HIGHLAND SPRINGS COMMERCIAL ADDITION

RE: S/D 00-15 -- Final Plat of HIGHLAND SPRINGS COMMERCIAL ADDITION

RE: S/D 00-15 -- Final Plat of HIGHLAND SPRINGS COMMERCIAL ADDITION

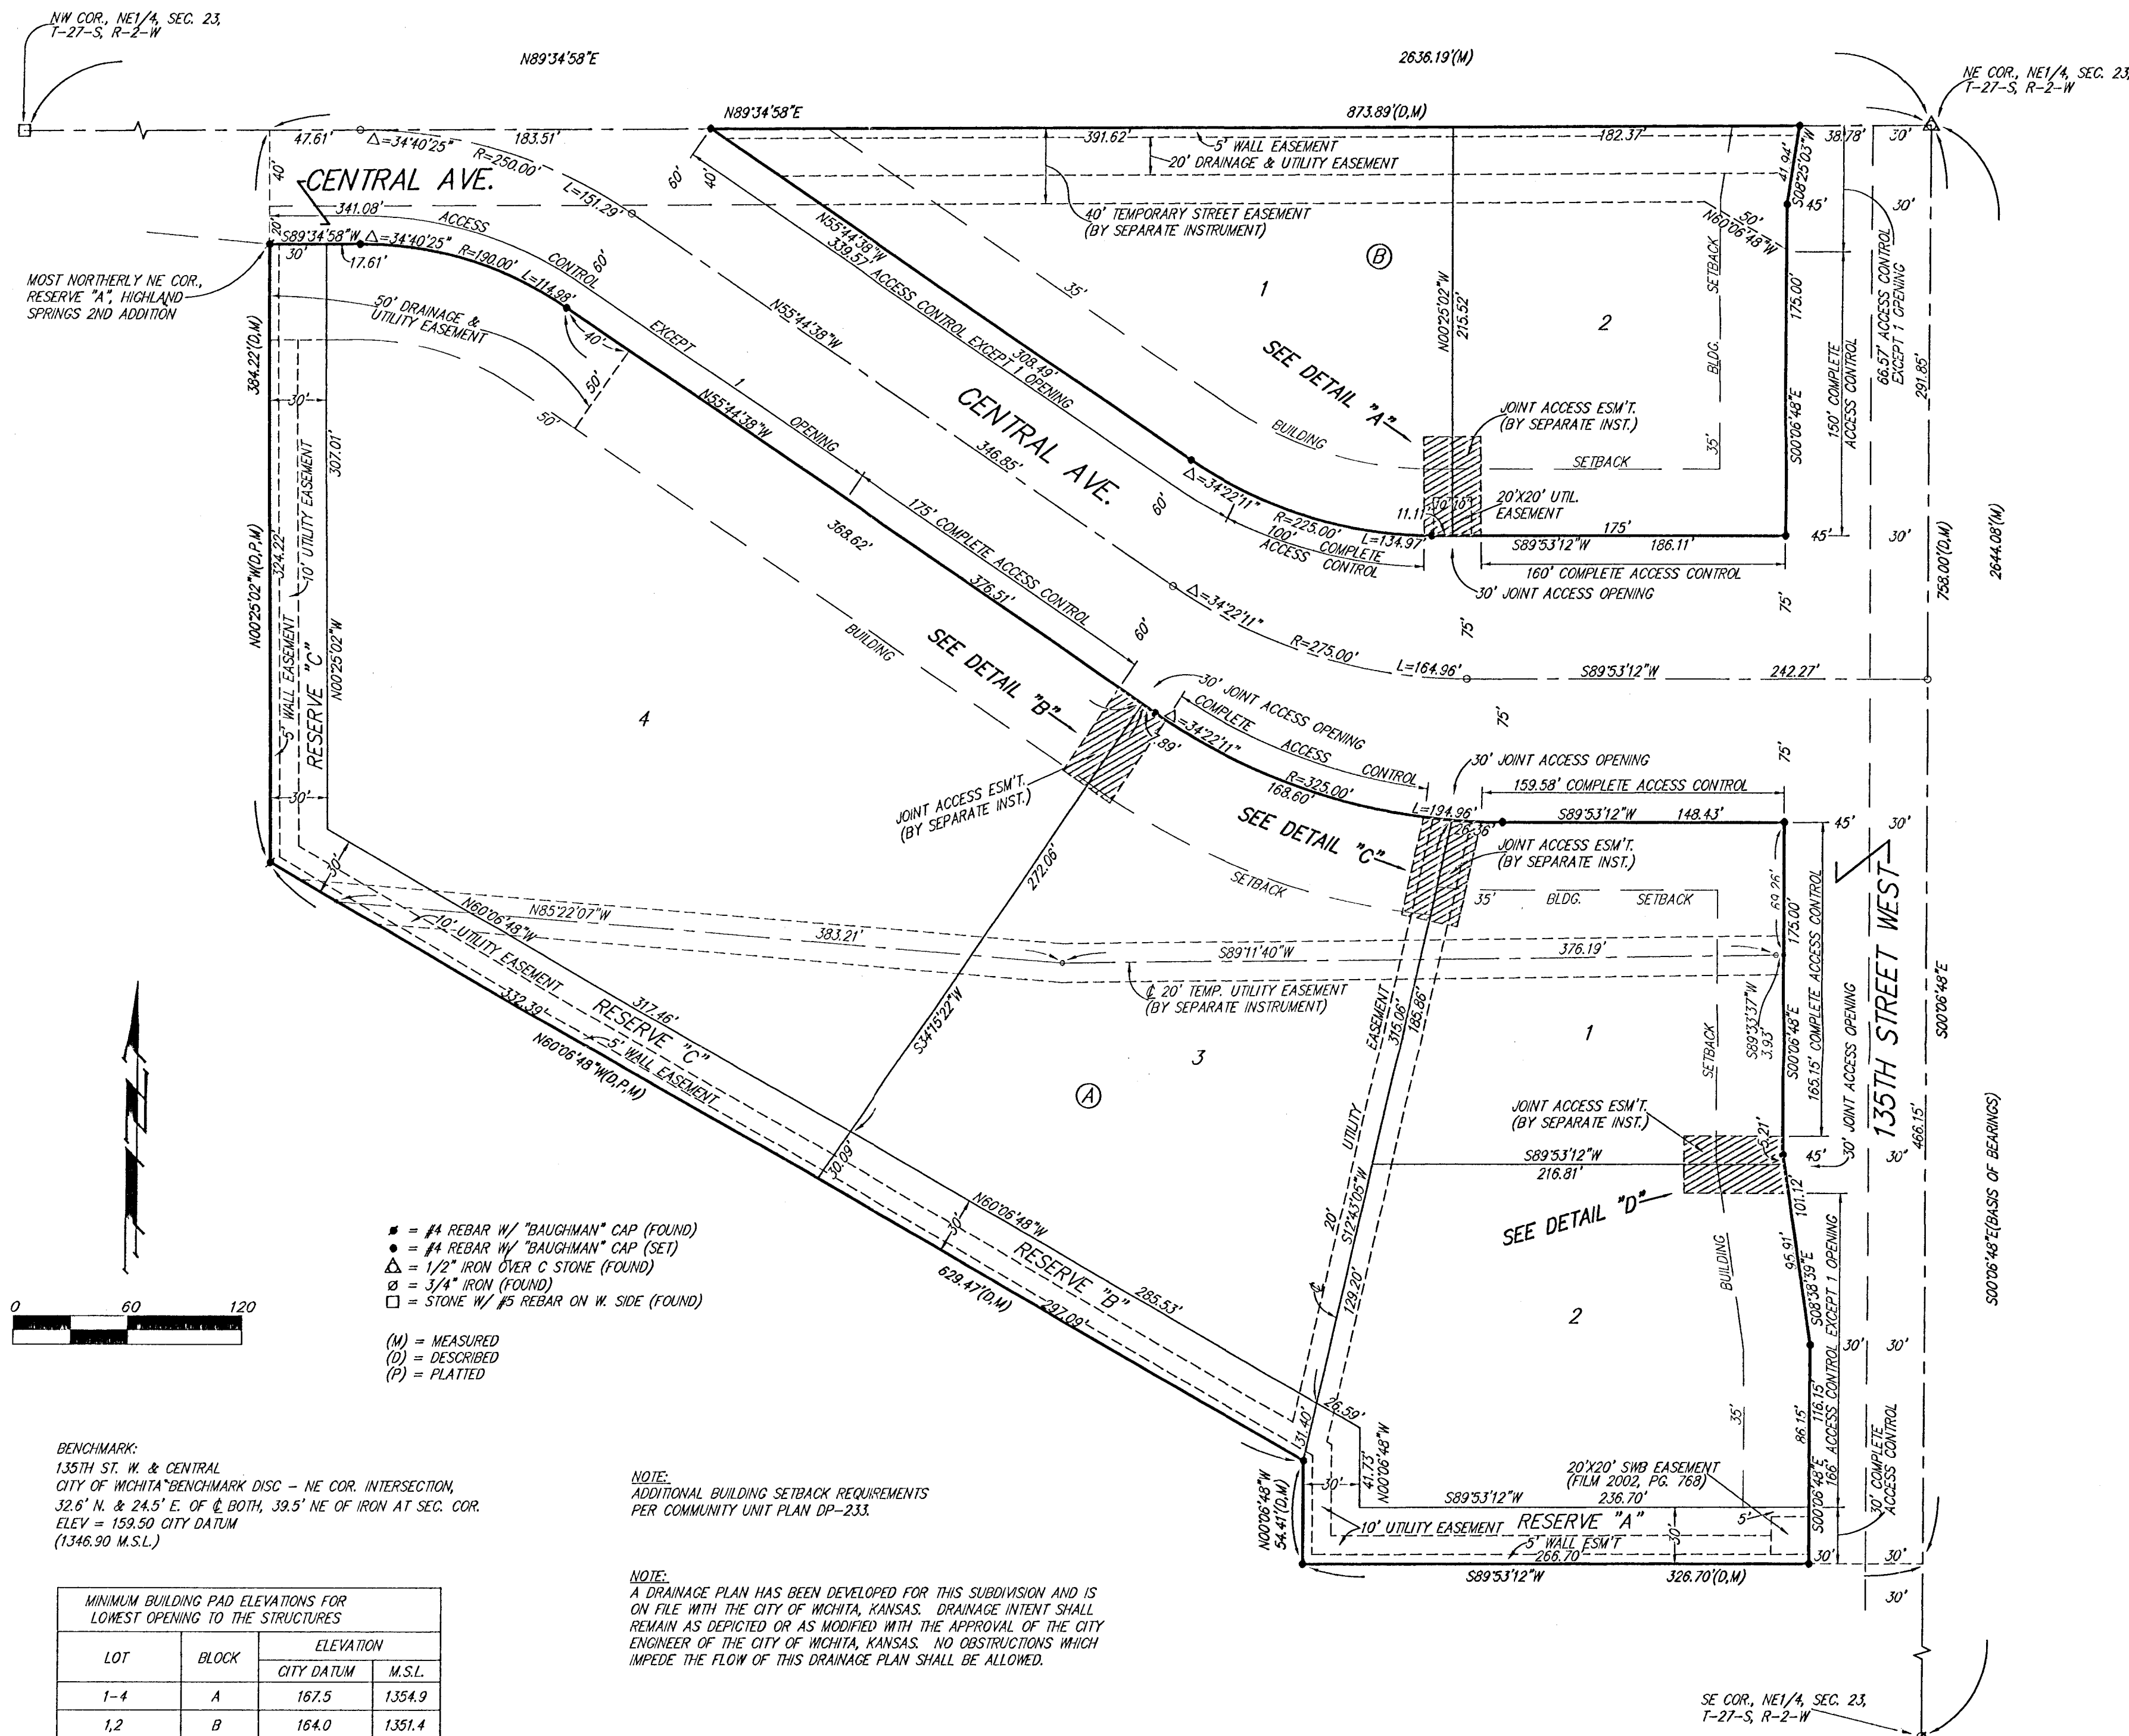
- D. The definite location of the KGE temporary easement needs to be provided on the plat.
- E. Traffic Engineering needs to comment on the access controls. The plat proposes three access openings along the south side of Central, including two joint openings. On the north side of Central two access openings are proposed, including one joint opening. Along 135th St. West, the plat proposes one access opening north of Central and two openings south of Central. For Lot 2, Block B, 150 feet of complete access control is required along 135th St. Distances should be shown for all segments of access control. In accordance with the Subdivision regulations, any access openings located within 250 feet of the intersection of Central and 135th St. West are limited to right-turns only, and shall be referenced on the face of the plat; or a guarantee provided for the future construction of a raised medial. The final plat shall reference the access controls in the plat's text.

- G. A temporary road easement for Central Avenue will need to be established by separate instrument until the improvements to the new alignment of Central are completed.

- H. The joint access openings need to be established by separate instrument.
- I. A cross-lot circulation agreement shall be provided between the non-residential lots.

- L. The plat's text shall include language that a drainage plan has been developed for the plat and that all drainage easements, rights-of-way, or reserves shall remain at established grades or as modified with the approval of the applicable City or County Engineer, and unobstructed to allow for the conveyance of stormwater.

- D. The definite location of the KGE temporary easement needs to be provided on the plat.
- E. Traffic Engineering needs to comment on the access controls. The plat proposes three access openings along the south side of Central, including two joint openings. On the north side of Central two access openings are proposed, including one joint opening. Along 135th St. West, the plat proposes one access opening north of Central and two openings south of Central. For Lot 2, Block B, 150 feet of complete access control is required along 135th St. Distances should be shown for all segments of access control. In accordance with the Subdivision regulations, any access openings located within 250 feet of the intersection of Central and 135th St. West are limited to right-turns only, and shall be referenced on the face of the plat; or a guarantee provided for the future construction of a raised medial. The final plat shall reference the access controls in the platting's text.

- T. The representatives from the utility companies should be prepared to comment on the need for any additional utility easements to be platted on this property. **KGE requests a temporary easement to cover their line until Central is realigned. Any relocation or reconstruction of utilities made necessary by this plat shall be the responsibility of the Applicant.**
